SERVICE BULLETIN

No. 546

Piper Aircraft Corporation

Subject: Inspection of Whelen Wing Tip Strobe Lights;
Reference F.A.A. Airworthiness Directive
75-05-04

WHELEN NAVIGATION AND STROBE LIGHT ASSEMBLY

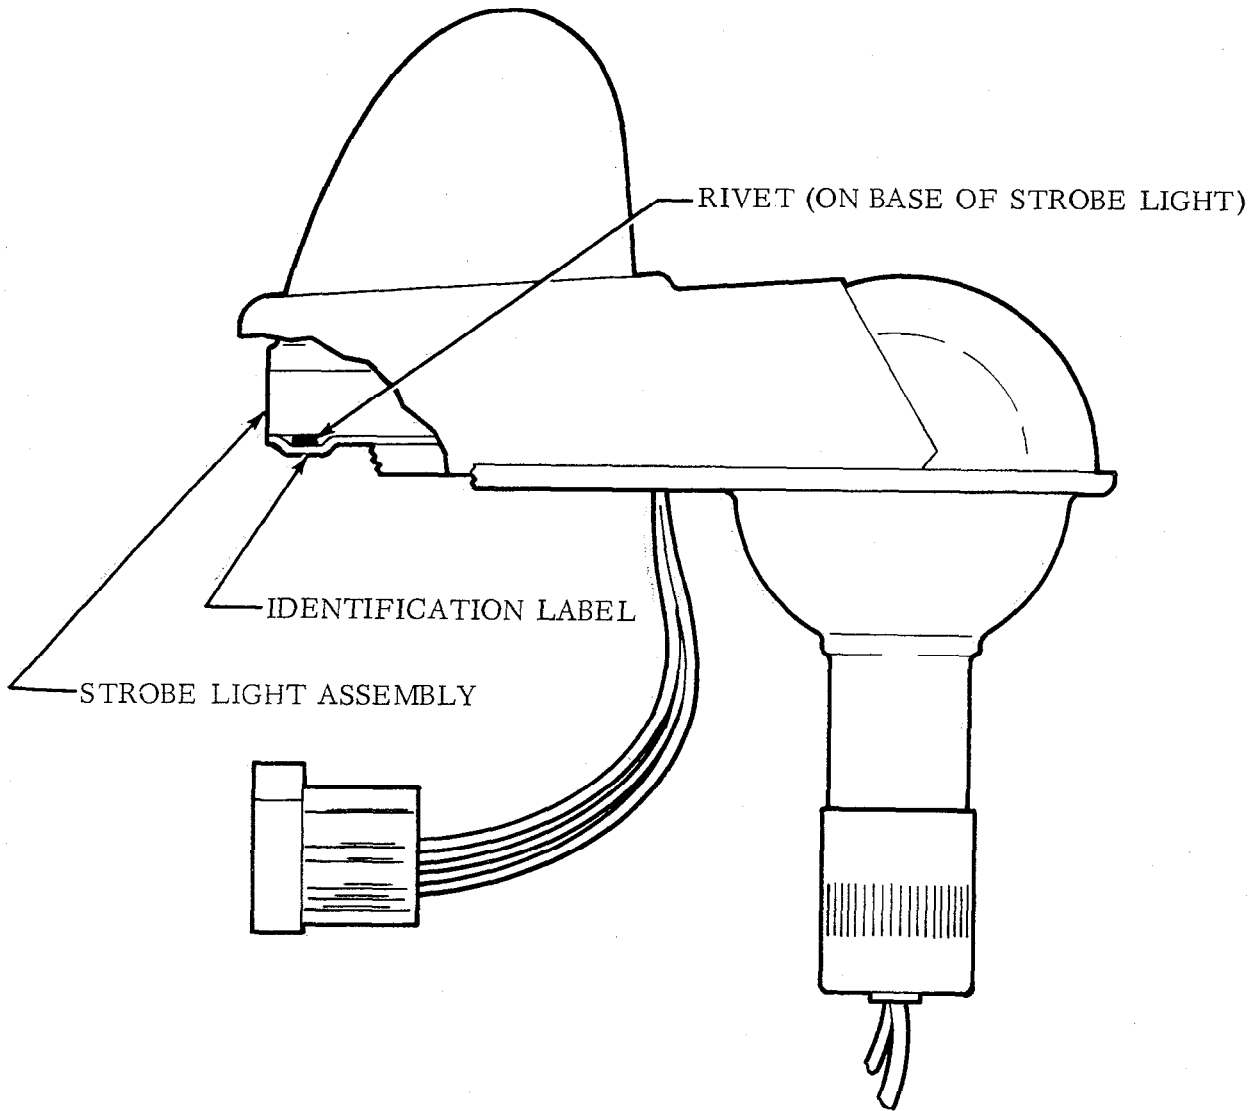
1. Expose wing tip strobe light assembly to view (refer to attached sketch for a typical strobe light assembly illustrated view).
2. If the following modification has already been accomplished, no further action is required; make appropriate entry in aircraft log book re compliance with this Service Release.

3. If the following modification has not been accomplished, proceed as follows:
 - a. Install on the base of the Whelen A-427 Flash Tube Assembly a pressure sensitive vinyl label conforming to Whelen drawing no. A-30052, Revision 1 dated October 15, 1974 or later F.A.A. approved revision.

1. Scotch Brand Type 33+ Vinyl Plastic electrical tape or equivalent tape - approved by an F.A.A. Maintenance/Avionics Inspector may be used in lieu of the vinyl label (if any plastic tape is used, it must be formed to cover the rivet at the rear of the flash tube without covering the identifying part number).

3. b. If the flash tube incorporates a label, the new label or tape may be installed directly over the old label.
- c. Install label or tape only when the label or tape and the flash tube are at a temperature above 50 degrees F.
4. Make appropriate service release compliance entry in aircraft log book.
